CHANGE ORDER NO. 2 - MARCH 28, 2008

CITY OF ROCKWALL, TEXAS

**FANNIN STREET IMPROVEMENTS
EXIST. Y-INLET MODIFICATIONS**

SHEET NO.
48A

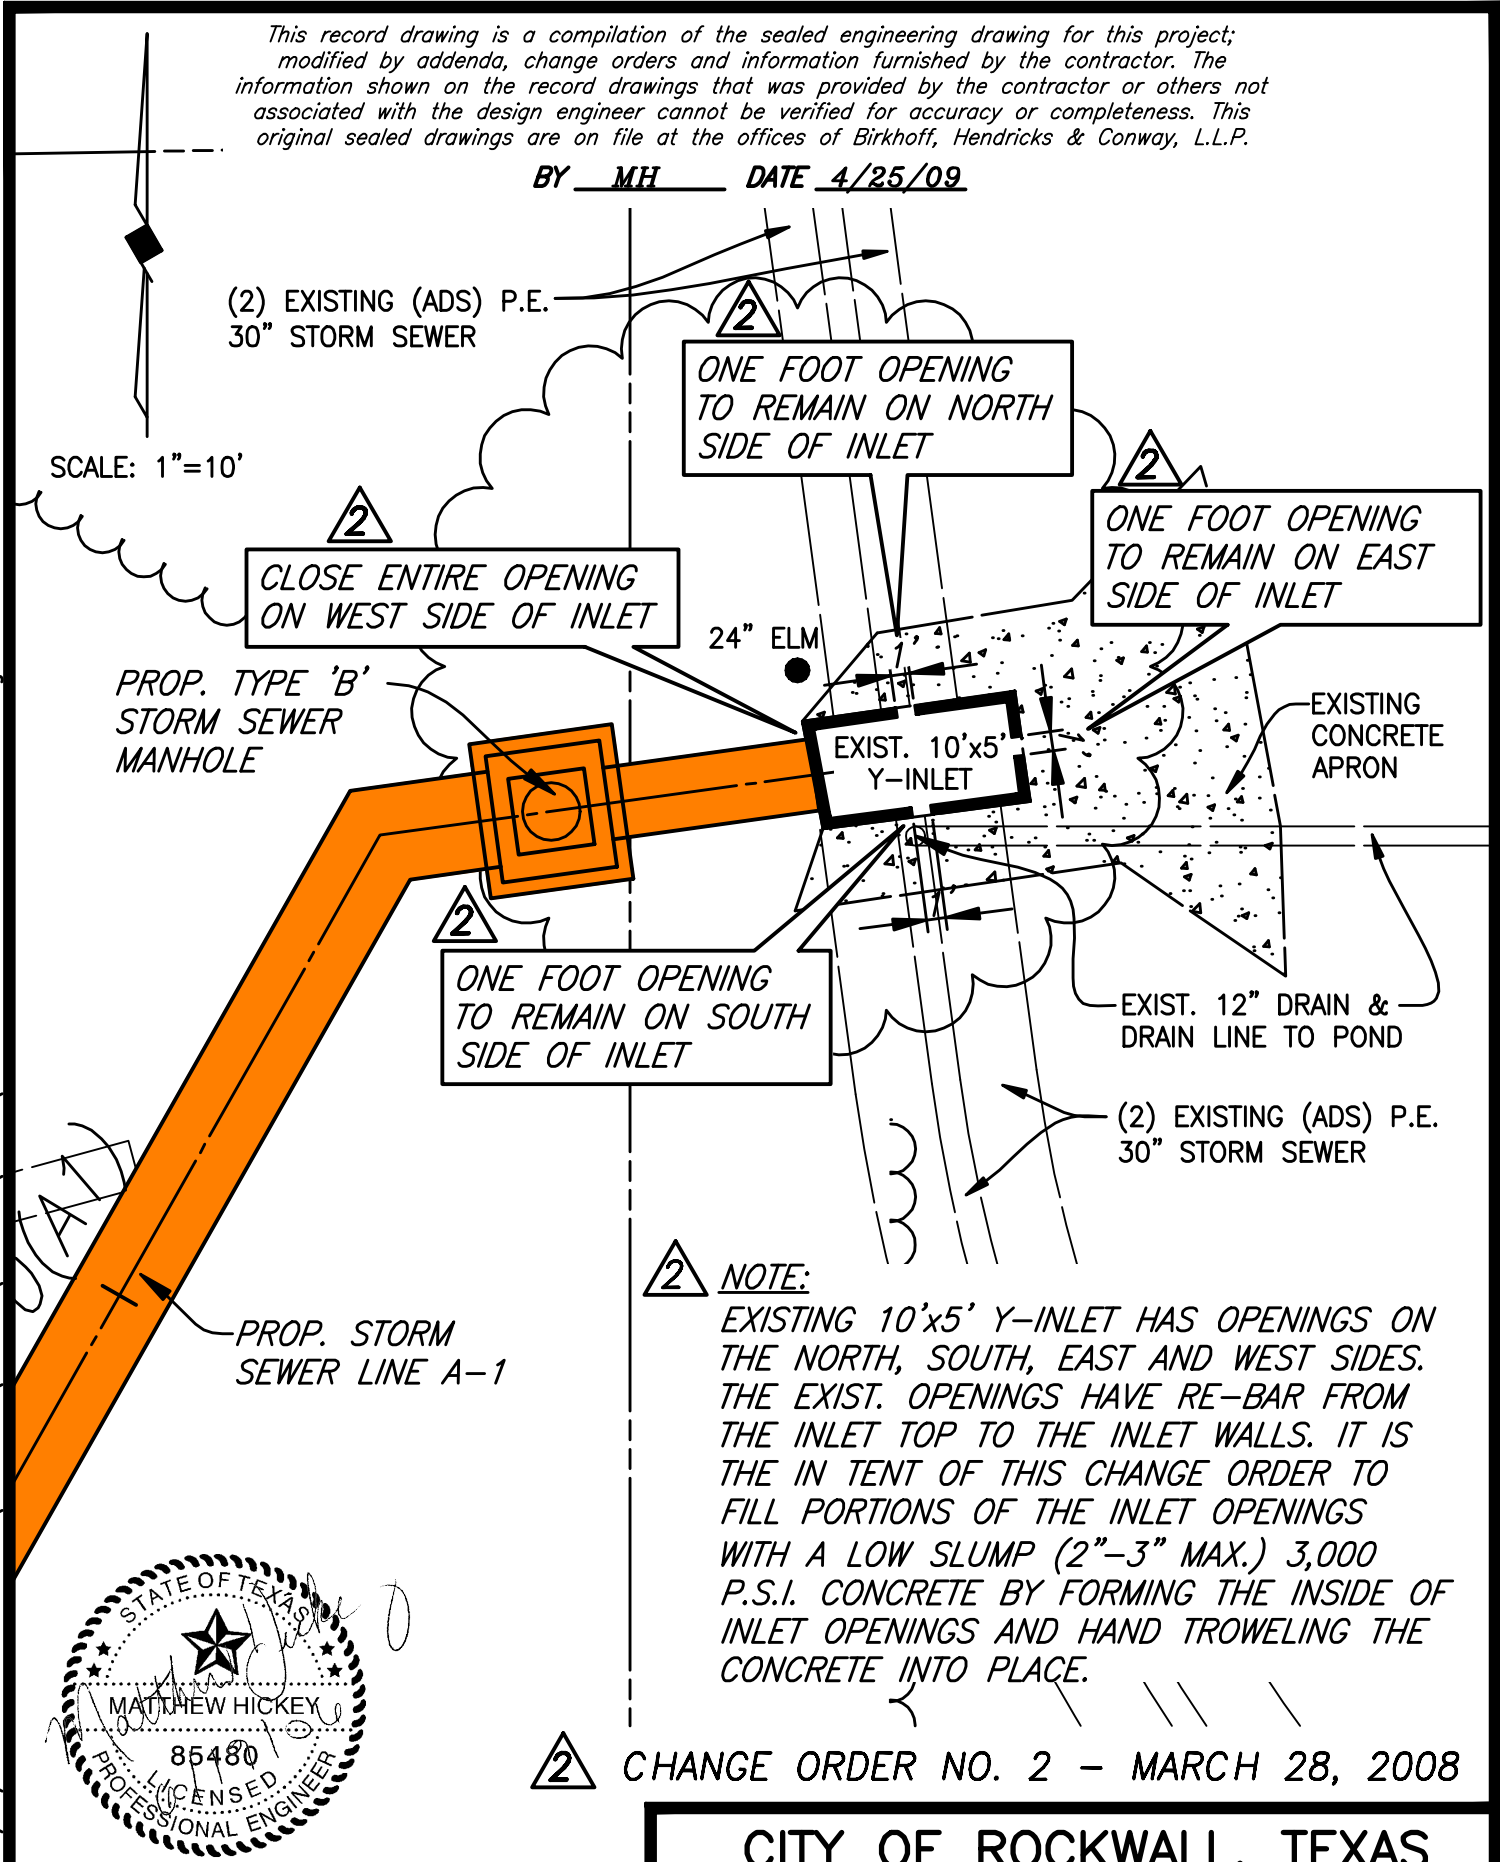
ONE FOOT OPENING TO REMAIN ON NORTH SIDE OF INLET

ONE FOOT OPENING TO REMAIN ON EAST SIDE OF INLET

CLOSE ENTIRE OPENING ON WEST SIDE OF INLET

ONE FOOT OPENING TO REMAIN ON SOUTH SIDE OF INLET

NOTE:
EXISTING 10'x5' Y-INLET HAS OPENINGS ON THE NORTH, SOUTH, EAST AND WEST SIDES. THE EXIST. OPENINGS HAVE RE-BAR FROM THE INLET TOP TO THE INLET WALLS. IT IS THE INTENT OF THIS CHANGE ORDER TO FILL PORTIONS OF THE INLET OPENINGS WITH A LOW SLUMP (2"-3" MAX.) 3,000 P.S.I. CONCRETE BY FORMING THE INSIDE OF INLET OPENINGS AND HAND TROWELING THE CONCRETE INTO PLACE.
